SYSTEM 80

CESSAR FSAR

DOCKET STN 50-470

RESPONSES TO QUESTIONS ON SLB METHOD

FIGURE 440.8-1  
CORE INLET ENTHALPY PROFILE  
DIAGRAM AT THE TIME OF MCHFR

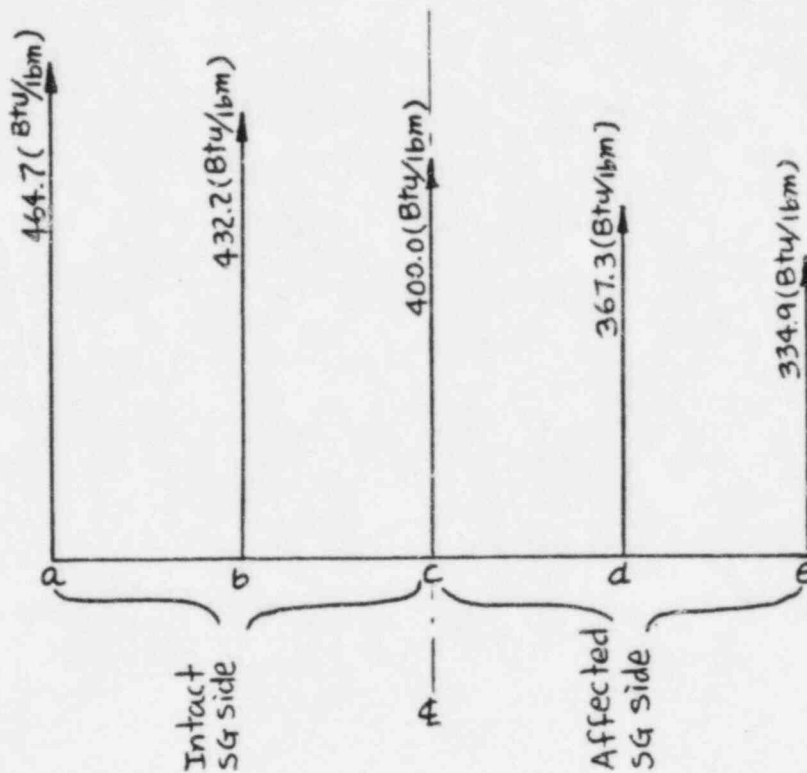
Provide parametrics or experimental results that indicate the conservatism in the above method for determining the hot channel inlet enthalpy.

A typical core inlet enthalpy profile diagram at the time of the minimum CHF is shown on Figure 440.8-1. The hot channel inlet enthalpy is set equal to the value at point d (mid point on the side associated with the affected steam generator). The values of the CHF obtained using the enthalpies of Figure 440.8-1 are given in Table 440.8-1.

The CHFR values of Table 440.8-1 were all calculated using the same values of all other parameters except enthalpy (i.e., power, pressure flowrate, peaking factor, etc). However the reactivity calculation is based upon the assumption that the stuck CEA is on the cold edge of the core (i.e., near point e) this means that the peaking factor is applicable only somewhere between points d and e. The actual CHFR at points a, b, and c would be much greater than the values shown in the table because of much smaller peaking factors at these locations. The minimum CHFR would be at the location of the stuck CEA with its associated very large peaking factor. Therefore use of the enthalpy at point d will produce a conservatively low minimum CHFR.

FIGURE 440.9-1  
THE MINIMUM PRE-TRIP DNBR vs  
STEAM GENERATOR INITIAL WATER MASS

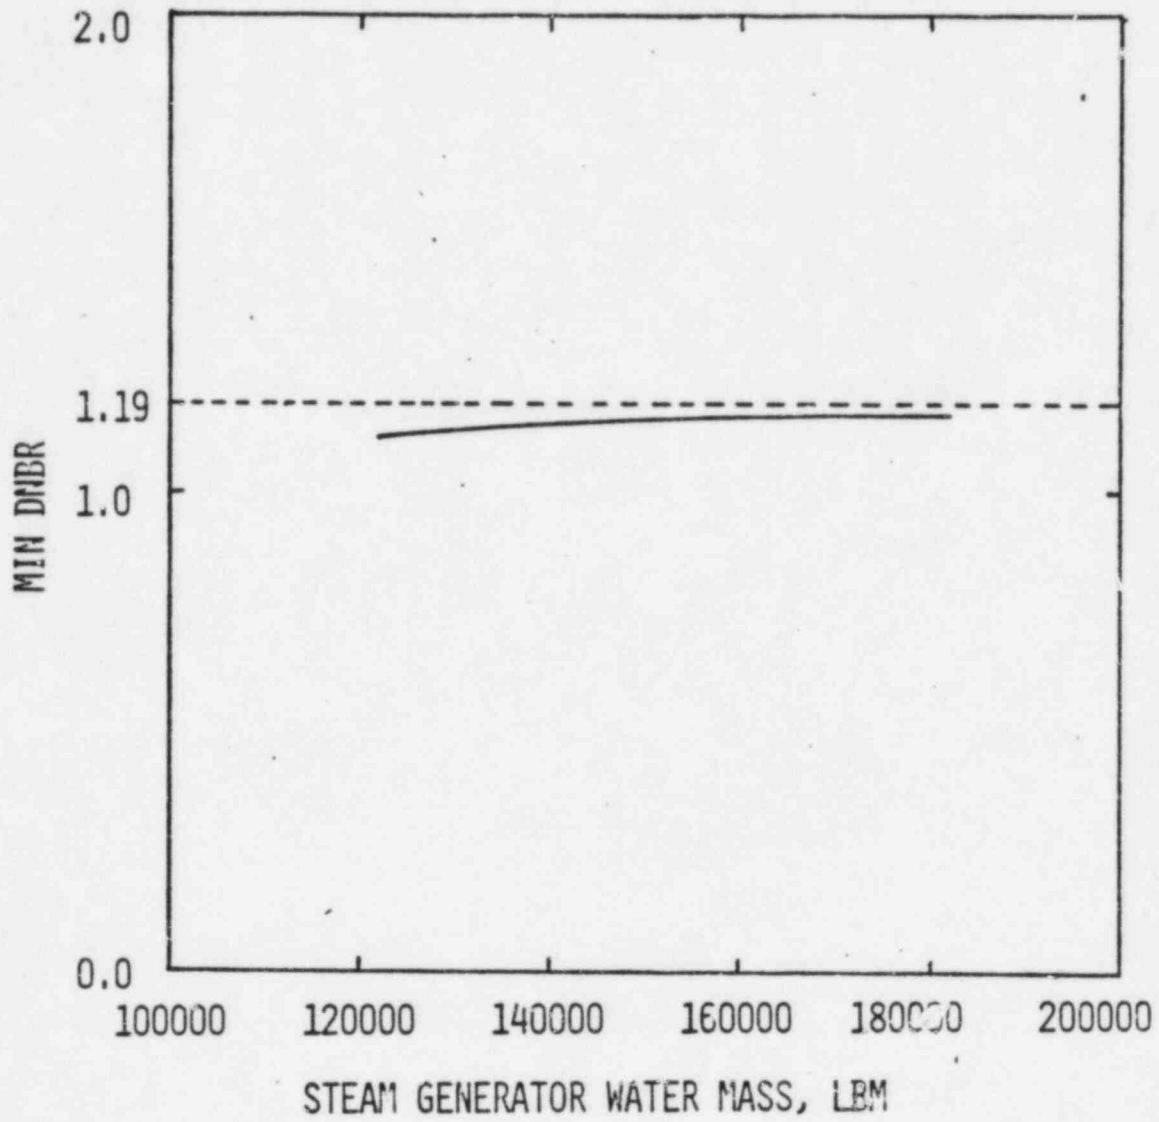
"The minimum DNBR resulting from a steam line break is insensitive to the initial steam generator water level. Confirm this conclusion by providing a plot of minimum DNBR as a function of initial steam generator water level.

The minimum pre-trip DNBR as a function of steam generator initial water mass is presented in Figure 440.9-1.

Figure 440.13-1

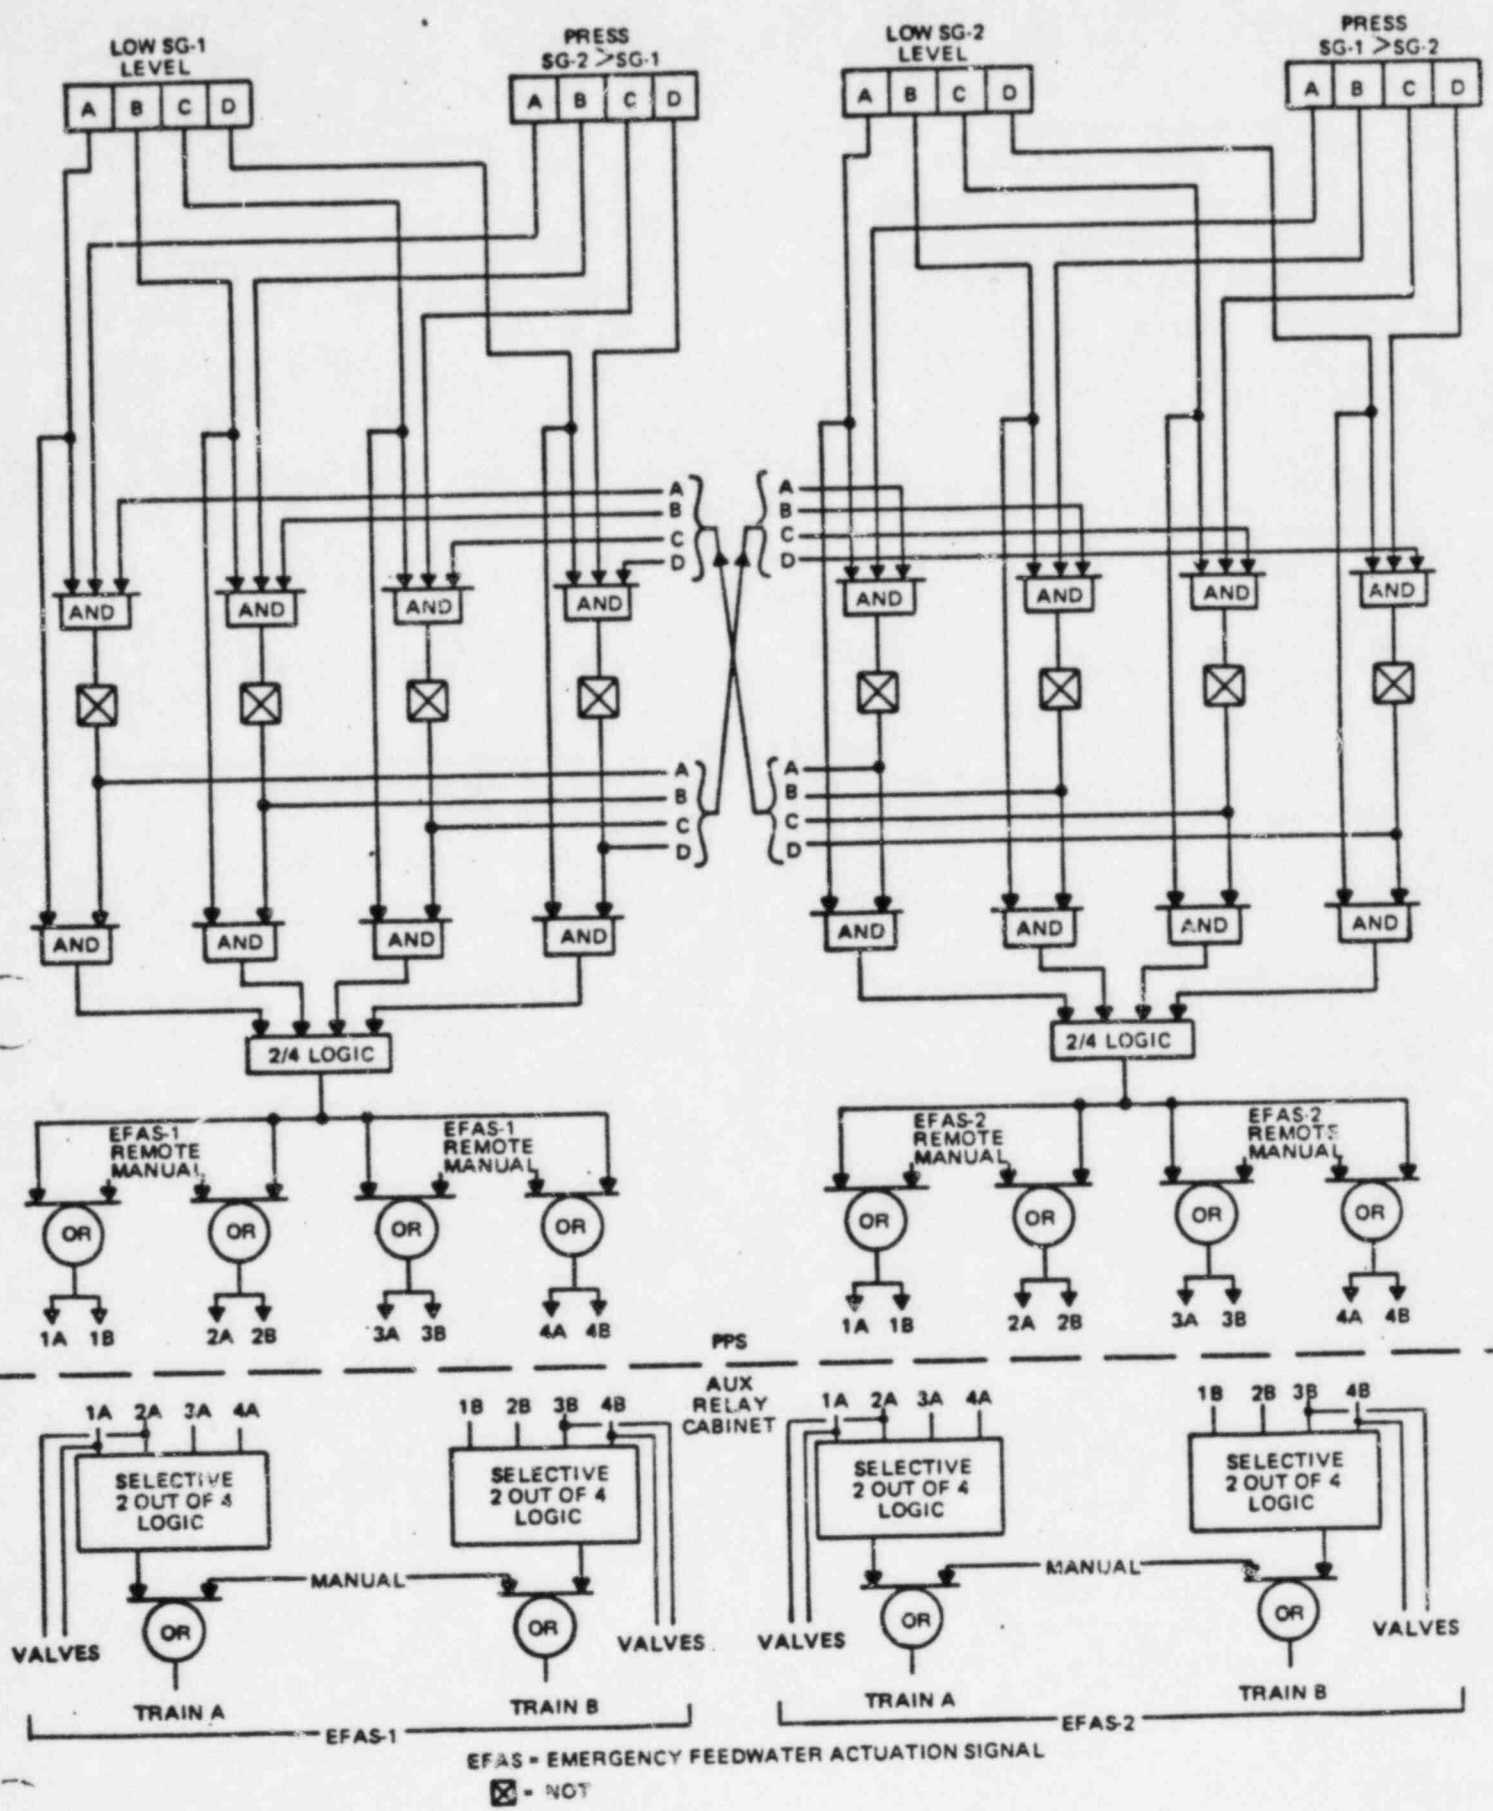
Provide a plot of minimum transient DNBR as a function of time for inadvertent actuation of auxiliary feedwater to the affected steam generator. The emergency feedwater actuation signal (ESFAS) logic may prevent feeding the affected steam generator, but may not preclude manual override.

The Emergency Feedwater Actuation Signal (EFAS) is one of the six signals of the Engineered Safety Features Actuation System (ESFAS). (See Section 7.3.2.2.6 of the CESSAR FSAR.) Manual override of the ESFAS is not part of the design bases for safety analysis.

The emergency (auxiliary) feedwater system (EFWS) is actuated by an EFAS as shown in Figure 440.13-1 (CESSAR Figure 7.3-1d). The EFAS actuates emergency feedwater on low water level to the intact steam generator(s). The Emergency feedwater actuation is based on the following condition: When a low steam generator water level signal exists the emergency feedwater is actuated to the steam generator with the low level only if the pressure of that steam generator is not lower than that of the other steam generator pressure by a pre-set value.
